From: [REDACTED]
To: [KapuniGreen](#)
Subject: Generation Zero comments
Date: Thursday, 21 October 2021 4:02:10 pm
Attachments: [Feedback on Kapuni Green Hydrogen project- landscape and risk.pdf](#)
[Commentary on Kapuni Hydrogen Project - Emily Bailey.pdf](#)
[21527-LET-001 Green Energy Taranaki FINAL.pdf](#)

Subject: Comments relating to land use safety planning for Hiringa Energy's fast tracked Kapuni Green Energy Project

In regards to a consent application with the Environmental Protection Authority (EPA) for the **Kapuni Green Hydrogen Project** under the COVID-19 Recovery (Fast-track Consenting) Act 2020 (the Act), by Hiringa Energy Limited and Ballance Agri-Nutrients Limited (the Applicants).

Feedback - Kapuni Green Hydrogen project- Landscape and Risk

Figure 3.6: Extract from STDP Special Map 03

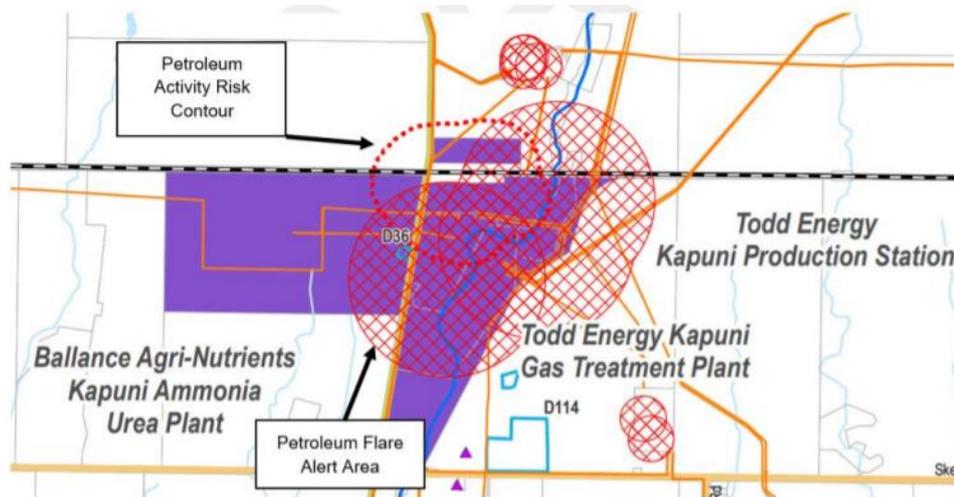
- Section 4.7 notes that the Operative South Taranaki District Plan (STDP) has been reviewed to understand the cumulative effects for the Todd Energy facilities located across the road from the loadout facility based on Special Map 03. This map (reproduced on following page) only shows the risk contour around the Todd Energy Kapuni Production Station. There is no risk overlay for the Gas Treatment Plant (as it was not available for the STP). However a separation distance of 650m to sensitive locations is required for this facility which would extend over the H₂ facilities (see <https://www.southtaranaki.com/repository/libraries/id:27mlbegko1cxbyf94es5/hierarchy/Documents/District%20Plan/District%20Plan%202015/Sections/Section%203%20Rural%20Zone%20Rules.pdf> at digital p.9). There is also no risk overlay for the Balance Ammonia Urea plant as this is not a petroleum facility (and under the STDP risk overlays only apply to petroleum facilities).

- It is possible that either of these facilities have a risk footprint that would reach the proposed location of the hydrogen refueling station.

- In my view the cumulative risk associated with all surrounding hazardous facilities has not been comprehensively addressed as required under the STDP. This should be addressed in greater detail and a clearer basis for discounting scenarios involving the H₂ pipeline also provided.
